The manuscript by Sheridan et al. compares wind data from several numerical products against floating lidar buoy observations from two sites along the US Pacific Coast. This is relevant and interesting in particular because of the future relevance of the region for offshore wind energy utilization. This is also the main strength, why I like the manuscript not really the scientific novelty.

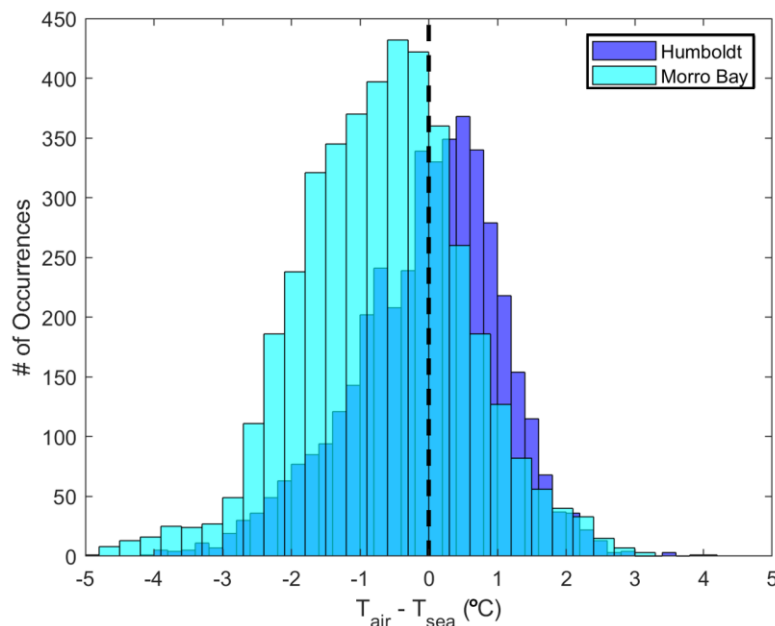
- Line 273 You mention that RAP is the best performing model at both sites. But there is no reason / interpretation given why.

We have added the following sentence to our statement about RAP on Line 293:

“The high spatial resolution of RAP is a likely factor in the model success, providing ability to represent features and phenomena that the coarser models miss, as is explored in upcoming sections. It is also possible that the relatively rapid analysis cycle of RAP (hourly) versus some of the reanalyses may be a factor.”

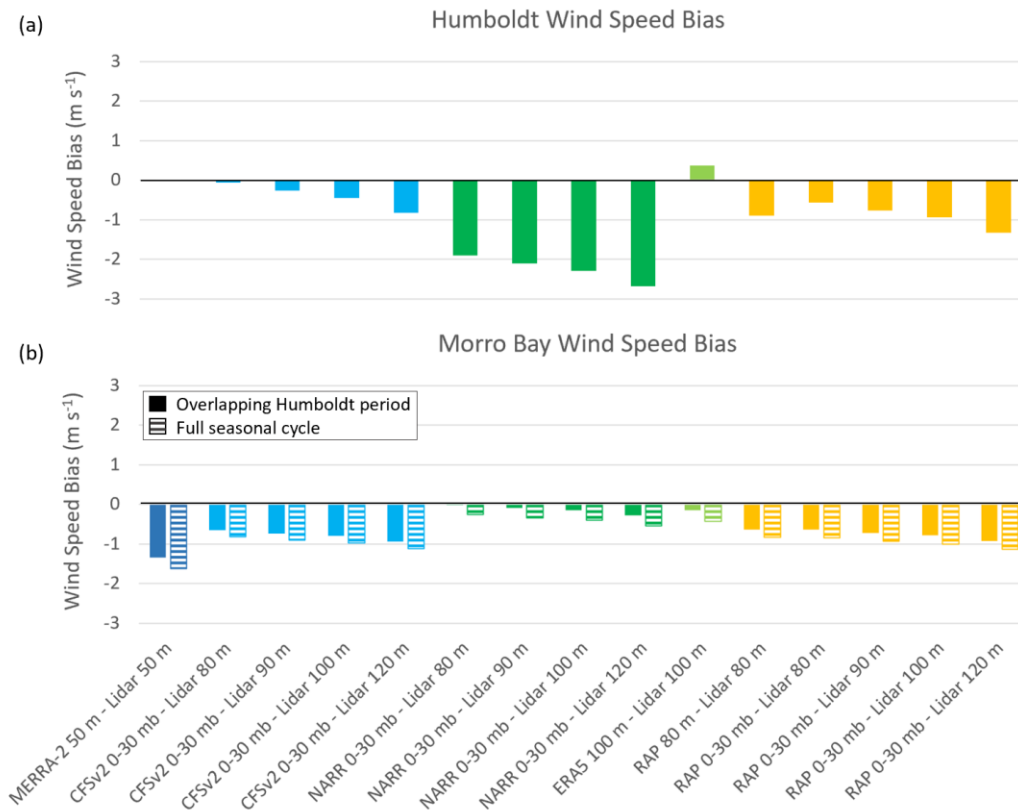
3. **Comparison of Humboldt and Morro Bay:** I think it is fair to show results for two different sites but a comparison of model performance for the two sites is just not possible at all. There is a distinct annual cycle in the wind condition along the coastline and the measurements do not overlap in time. Please remove any comparisons of the two sites from the manuscript that cover data from periods where the Humboldt measurement data weren't available.

The authors greatly appreciate the reviewer pointing out that comparing the two sites while they have different data coverage periods is not recommended. To address this suggestion and to add value, we have provided the following metrics throughout the paper:

1. Metrics at Humboldt for the Humboldt data coverage periods of 1 October 2020 – 27

December 2020 and 25 May 2021 – 30 September 2021

2. Metrics at Morro Bay during the overlapping Humboldt data coverage periods of 1 October 2020 – 27 December 2020 and 25 May 2021 – 30 September 2021, in order to compare with Humboldt

3. Metrics at Morro Bay for the full deployment period of 1 October 2020 – 30 September 2021, in order to examine the full seasonal cycle at this location

Line 97 now states: “In this article, the period of study for both buoys is 1 October 2020 to 27 December 2020 and 25 May 2021 to 30 September 2021. Additionally, the full seasonal cycle of 1 October 2020 to 30 September 2021 is analysed for Morro Bay.”

Figures have been updated throughout the text to provide both the overlapping period between the two buoys and the full Morro Bay seasonal cycle, as the following example shows:
